UNITED STATES PATENT AND TRADEMARK OFFICE

APPLICATION NO.	FILING DATE	FIRST NAMED INVENTOR	ATTORNEY DOCKET NO.	CONFIRMATION NO.
10/574,617	04/05/2006	Naoto Yokoyama	0033-1073PUS1	2104
2292 7590 01/26/2009 BIRCH STEWART KOLASCH & BIRCH PO BOX 747 FALLS CHURCH, VA 22040-0747				
EXAMINER CHANG, CHARLES S				
ART UNIT 2881		PAPER NUMBER		
NOTIFICATION DATE 01/26/2009		DELIVERY MODE ELECTRONIC

DETAILED ACTION

FIG.2

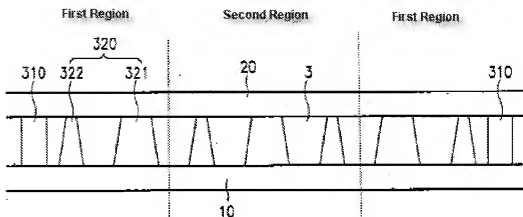
Regarding claim 4, Cho discloses a liquid crystal display panel comprising: two substrates (10, 20) fixed together by a seal member (310) with their main surfaces opposed to each other; liquid crystal (3) sealingly stored in a region surrounded by said two substrates and said seal member and a plurality of columnar spacers (320) arranged in the region surrounded by said two substrates and said seal member, wherein said columnar spacers include: a first columnar spacer (321), and a second columnar spacer (322) being higher than said first columnar spacer when receiving no

load; said first columnar spacer is arranged in a first region near an inner side of said seal member and a second region located inside said first region; and said second columnar spacer is arranged in said second region (Fig. 2 below; Fig. 3). Cho does not explicitly disclose each of said plurality of second column spacers being arranged at a rate of one spacer per ten picture elements, and each of said plurality of first column spacers being arranged at a rate of one spacer per fifteen picture elements. Cho teaches the concentrations of the first and second spacers (section 0013). It would have been obvious at the time of the invention to one of ordinary skill in the art to have each of said plurality of second column spacers being arranged at a rate of one spacer per ten picture elements, and each of said plurality of first column spacers being arranged at a rate of one spacer per fifteen picture elements, since it has been held that discovering an optimum value of a result effective variable involves only routine skill in the art. *In re Boesch*, 617 F.2d 272, 205 USPQ 215 (CCPA). Cho also does not necessarily disclose the height of the second column spacers being 45 percent of the width of the second column spacers, and the height of the first column spacers being 43 percent of the width of the first column spacers. Murouchi teaches the height of the second column spacers being 45 percent of the width of the second column spacers, and the height of the first column spacers being 43 percent of the width of the first column spacers (col. 3 lines 7-26). It would have been obvious at the time of the invention to one of ordinary skill in the art to have the height of the second column spacers be 45 percent of the width of the second column spacers, and the height of the first column spacers be 43 percent of the width of the first column spacers, since it has

been held that discovering an optimum value of a result effective variable involves only routine skill in the art. *In re Boesch*, 617 F.2d 272, 205 USPQ 215 (CCPA).
